## **REVIEW OF CLARKE SAUNDERS ASSOCIATES LETTER**

### **AS7531 MONKTON PARK SKATEPARK, CHIPPENHAM Noise Impact of Proposed Skatepark**

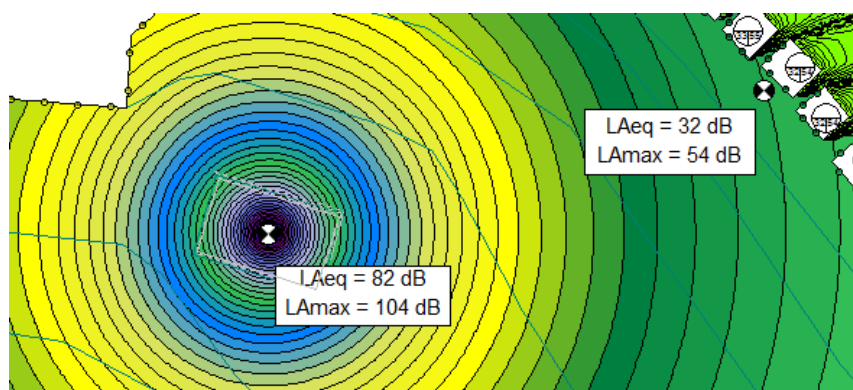
The next paragraph then states that this figure has been corrected to the centre of the skate park, a distance taken to be 5m from the measurement location.

*Figures 11 and 12 above show that the average noise levels measured at each skate park remain relatively constant when there is activity at the skate parks. Based on the location of the microphone during each skate park survey, calculations have been carried out to determine the noise levels at the centre of each skate park which was estimated to be approximately 5 metres distance from the microphone location. This calculated level can be defined as the reference source noise level. The following table summarises the calculated noise levels at the centre of each skate park*

The results are 82 dB  $L_{Aeq}$  and 104 dB  $L_{Amax}$  at the centre of the park. Figure 13 shows the noise map used to assess the spread of noise from the skate park. This illustration shows clearly that the sound pressure level in the centre of the park is equal to these values. For convenience, I have cropped the image and expanded it below.

There is therefore no need to add a 5m distance loss (-14 dB) as suggested by Jamie. The sound power levels given in Appendix C were calculated by Cadna. Appendix C shows a sound pressure to sound power conversion of 12 dB, this is more onerous than Jamie's 8 dB correction.
